LASALLE COUNTY STATION

**EVALUATION OF SIGNIFICANT HAZARD CONSIDERATIONS
FOR PROPOSED CHANGES TO**

**MAIN CONTROL ROOM ATMOSPHERIC CONTROL SYSTEM RADIATION
MONITORING INSTRUMENTATION TECHNICAL SPECIFICATION**

TITLE (4)
Inadequate Review of Modification of Main Control Room Atmospheric Control System Radiation Monitoring Logic Results in an Unreviewed Safety Question

UNIT 1(2) MCRACS RADIATION MONITOR TRIP LOGIC PRIOR TO INSTALLATION OF MODIFICATION M01-88-003A(B)

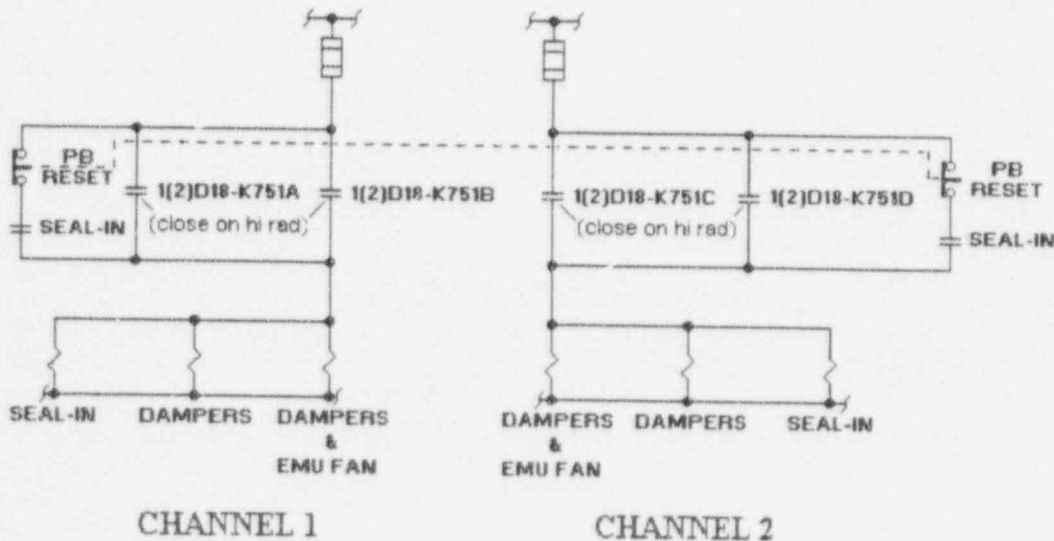
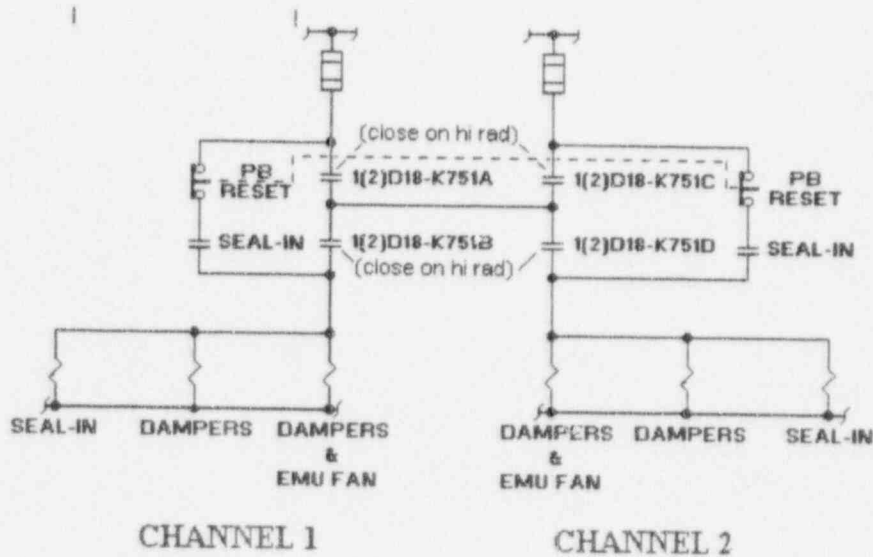
The root cause of the inadequate safety evaluation for the modifications performed in 1993 was that LaSalle County Station failed to recognize that damper isolation for the control room ventilation air intakes is not functionally redundant. Hence, the modified design would have allowed a single failure to result in the failure to isolate one train.

The AE incorporated the request and the revised design was issued in September, 1992. This design no longer met the channel redundancy requirements in the design basis. This was not recognized during the review and approval process as the new design appeared to be a basic simplification of the design change which had been proposed and reviewed numerous times since 1990.

1. A modification will be developed to correct the installed design. The original channel separation and redundancy will be restored. The revised design will meet the single failure criterion of the design basis.
2. The Technical Specifications will be revised to conform to the design and to eliminate confusion in the wording of the action statement.
3. An ongoing detailed system design review of the MCRACS is already in progress as a result of previous concerns as identified in LER 96017.
4. A review of other modifications to the MCR Ventilation System which could affect the single failure criteria as it applies to the MCR Isolation Dampers and Control Circuitry will be conducted.
5. A review of the changes which removed FSAR drawings from the UFSAR to ensure that the information contained on the drawings is adequately referenced in the UFSAR for subsequent Safety Reviews.
